Access Compliance Report

Public Rights-of-Way

Main Street: THISTLE_RD Cross Street: RAMM_DR Location: W

ADA ID: RPRK210924172927 Ramp Type: Type 6 - Directional 1 Initial Pass/Fail: Pass Overall Compliance: No Severity Score: 4

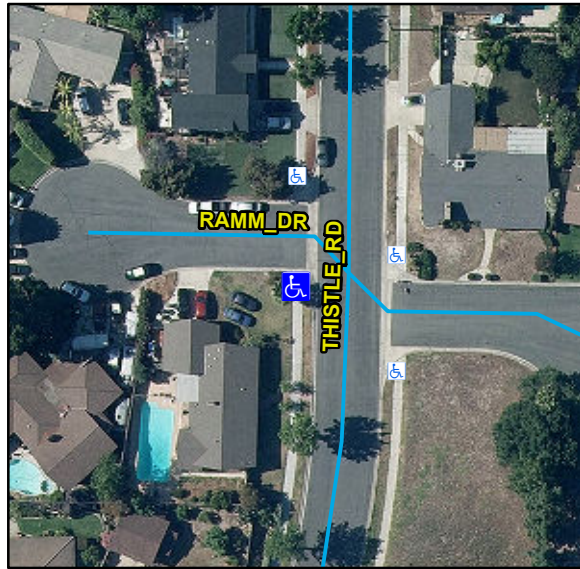
Compliance	Description	Data	Compliance	Description	Data
N/A	Ramp Length (in)	93	N/A	Flare Type LT	
Yes	Ramp Width (in)	60			Sloped
Yes	Ramp Run Slope (%)	2.4	No	Flare Slope LT (%)	11.5
Yes	Ramp Cross Slope (%)	0.7	N/A	Flare Traversable LT	Yes
Yes	Grade Break	Yes	Yes	Flare Type RT	
Yes	Grade Break Slope (%)	0			Curbed2
Yes	Grade Break Cross Slope (%)	1.9	N/A	Flare Slope RT (%)	N/A
	Addl Para Ramp Left?	No	N/A	Flare Traversable RT	N/A
	Addl Para Ramp Right?	No	Yes	DWS Provided	Yes
N/A	Landing Present	Yes	Yes	DWS Contrast	Yes
Yes	Landing Length (in)	115	Yes	DWS Length (in)	88
Yes	Landing Width (in)	60	Yes	DWS Full Width	Yes
No	Landing Run Slope (%)	2.5		DWS Offset Type	Single
Yes	Landing Cross Slope (%)	1	Yes	DWS Left Offset (in)	0
N/A	Landing Movement Obstructed?	No	N/A	DWS Right Offset (in)	0
	Landing Movement Type	N/A			
N/A	Landing Shared	No			
N/A	Marked Crosswalk 1	No	N/A	Clear Space	Yes
	Crossing 1 Direction	N	N/A	Clear Space To Crosswalk (in)	48

Remove & Replace Curb Ramp With Two New Directional Ramps or Equivalent.
